Contaminated Land Site Audit Report (SAR)

Department of Veteran Affairs

51, 53 and 55 Headfort Street, Greenslopes Queensland

BC200195.01

DEPARTMENT OF VETERAN AFFAIRS
DVA GREENSLOPES
51-55 HEADFORT STREET, GREENSLOPES, QLD
FIGURE 10 **DRAFT**
Imported Fill Sample Locations

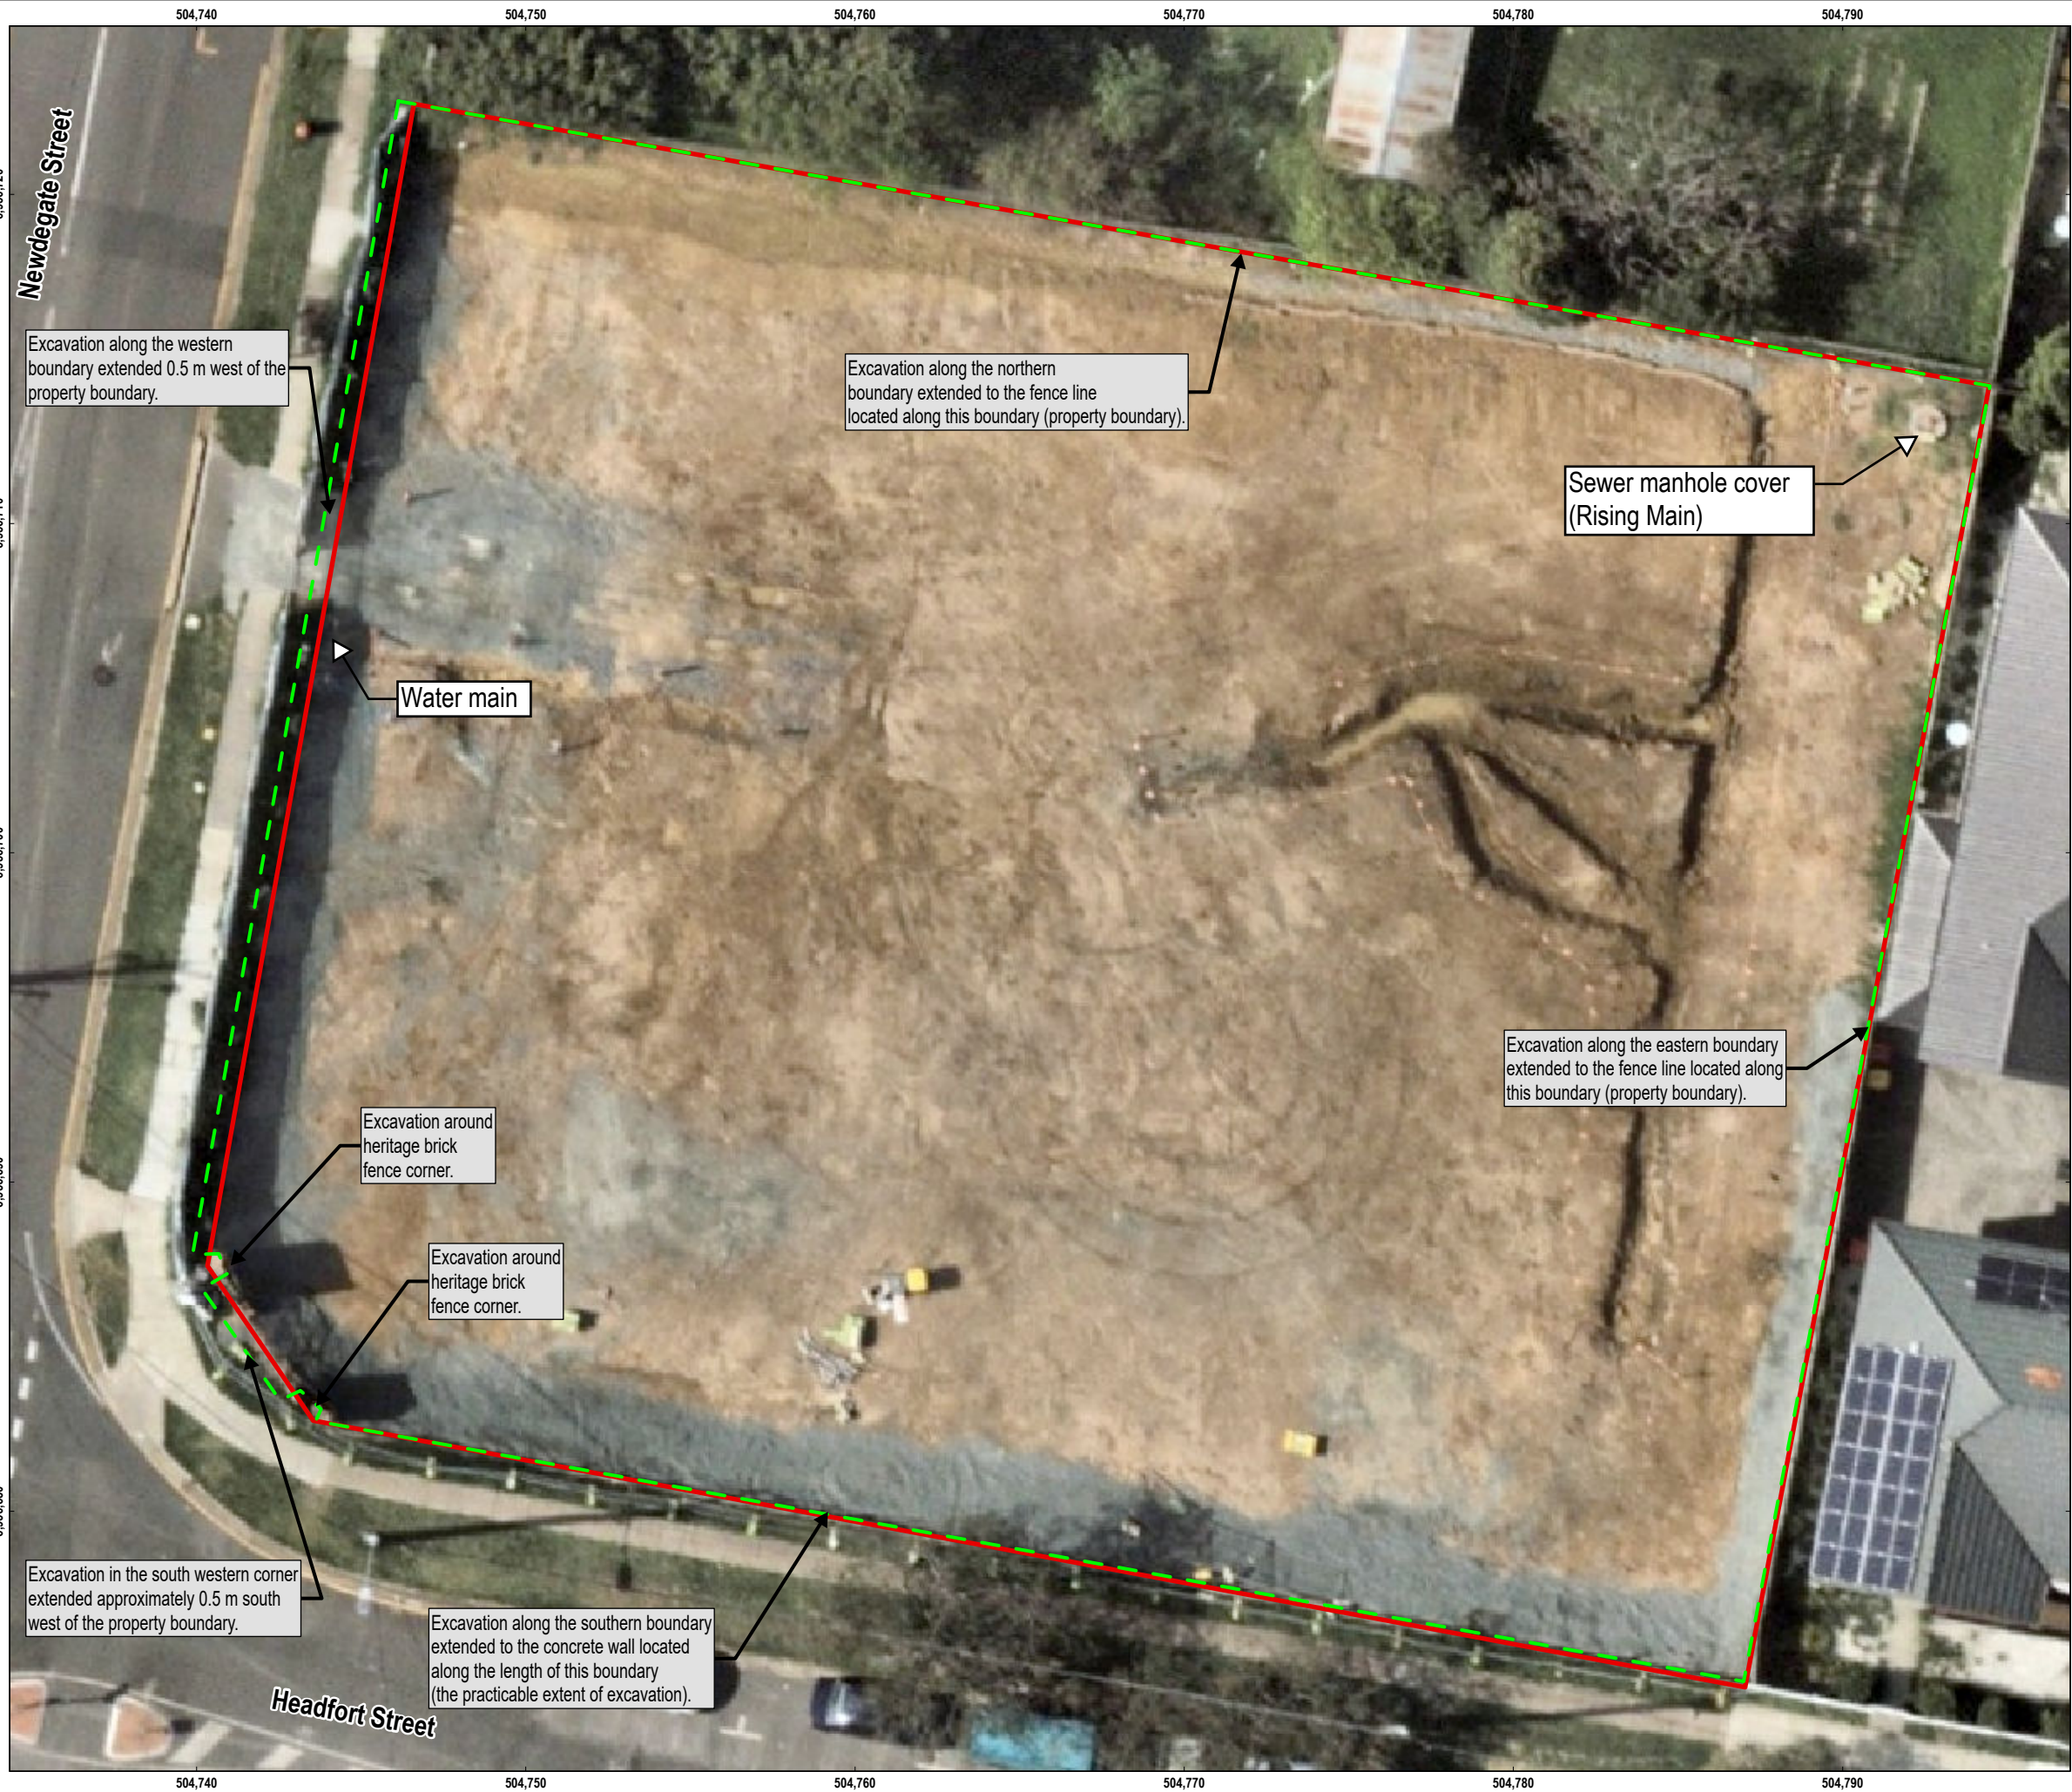
If needed I can show the approximate location of the stockpile/sample locations for CF01 to CF06 in Figure 10.
